SNUPPS

84-0014 FILE: 0278
Fire Protection Review

Docket Nos. STN 50-482 and STN 50-483

RESPONSES TO NRC FIRE PROTECTION

TYPICAL ELEVATION VIEW
AUXILIARY BUILDING CORRIDOR
CABLE TRAY SPRAY COVERAGE

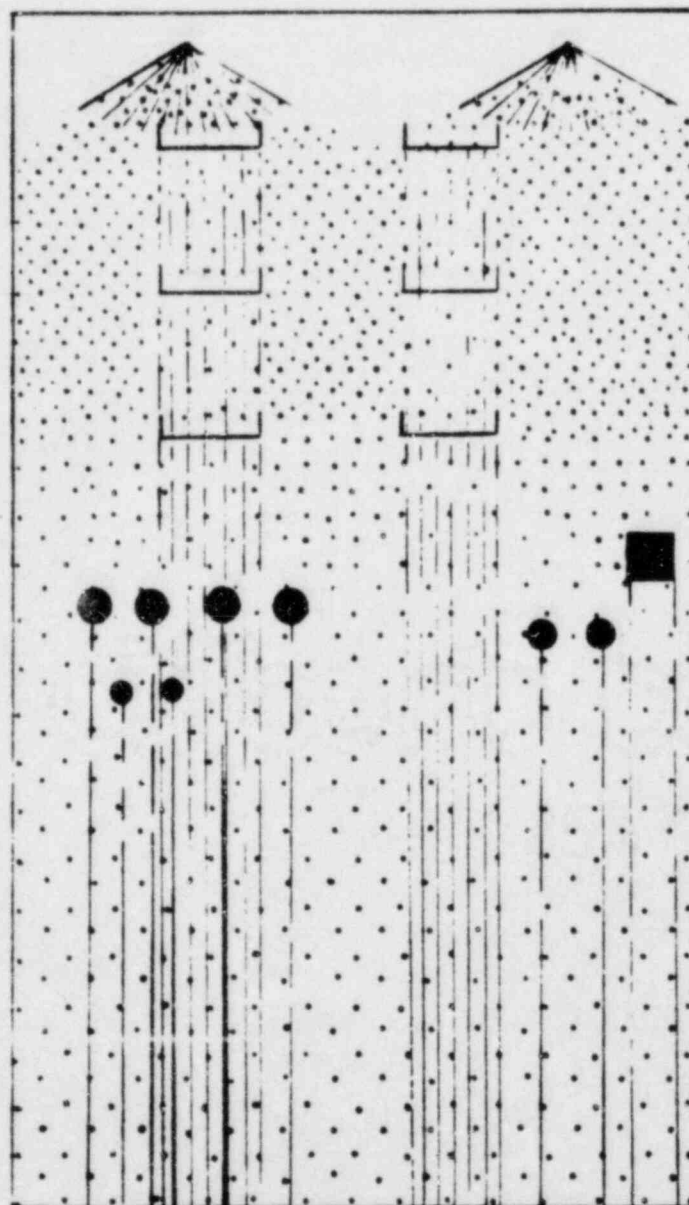
The NRC fire protection auditors indicated a general concern that certain auxiliary building corridors were too congested to allow the sprinklers located above cable trays to provide adequate coverage of the general floor area. Thus the cable trays were potentially lacking adequate protection from transient fires. The auditors suggested that additional sprinklers may be required below the lowest obstruction.

The concerns raised have been reviewed along with each auxiliary building corridor. Based on this review, it has been determined that no additional sprinklers are necessary. The following descriptions provide the bases for this determination.

The attached figure provides an elevation view of a typical corridor with two stacks of trays and a pictorial presentation of the head locations and sprinkler coverage. As shown the heads are located within inches of the ceiling and the 120° discharge cone of fine mist sized droplets pervades the cable tray area. The concentration of spray below the trays will be influenced by spray impingement on the walls, cable trays and any pipes which are present below the trays; however, due to the spray flow rate, the size of the droplets and turbulence due to the fire, a sufficient density of spray droplets will exist below the trays to control postulated transient fires until the fire brigade arrives.

Figure A

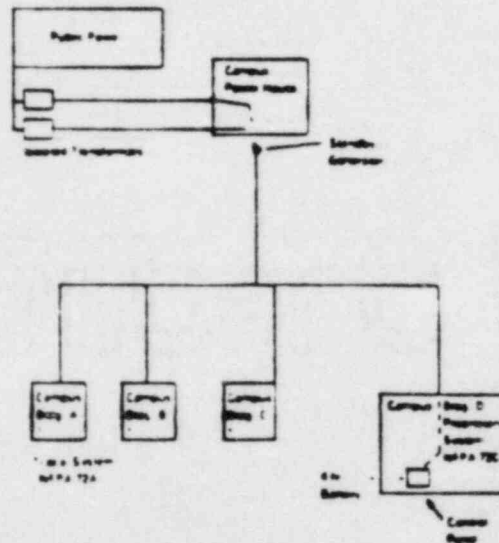
The NRC auditors indicated that the design of the SNUPPS protection system power supply was not in accordance with NFPA 72D and that standby power to remote fire protection panels and multiplexers should consist of 4 hr. rated batteries located at the panel.

Question: Based on Figure A, per paragraph 2223C, NFPA 72D 1975, are batteries with 4 hour capacity required at location A?

The basis for the NRC interpretation of NFPA 72D requiring the battery portion of the backup DC system to consist of 4 hour rated batteries located at the panels is an NFPA official interpretation dated August, 1977. This official interpretation was issued against the 1975 edition of NFPA 72D. A copy of this interpretation is included as Attachment A.

Regardless of the status of the subject O.I., the power source configuration questioned is not similar to that provided for SNUPPS. The O.I. system has a secondary source consisting of a standby generator serving all locations and 4 hr. batteries for only the main control panel. As indicated by Attachment B, all panels in the SNUPPS system can be powered by 125V batteries.

The O.I. specifies that given the indicated system power configuration, batteries with 4 hour capacity are required "at location A." Location A is a campus building not specifically a panel. The intent of this O.I. is to reiterate the requirement that remotely located control equipment/panels be provided with primary and secondary power supplies as detailed in NFPA 72D, section 2-6 (Article 220 of 1975 edition). Clearly, the system described in the O.I. does not meet the intent of this section since a battery source is provided only to the control panel and is not provided to the local systems. Failure of the standby generator upon loss of normal power will render the local systems out of service due to the lack of a DC battery source.
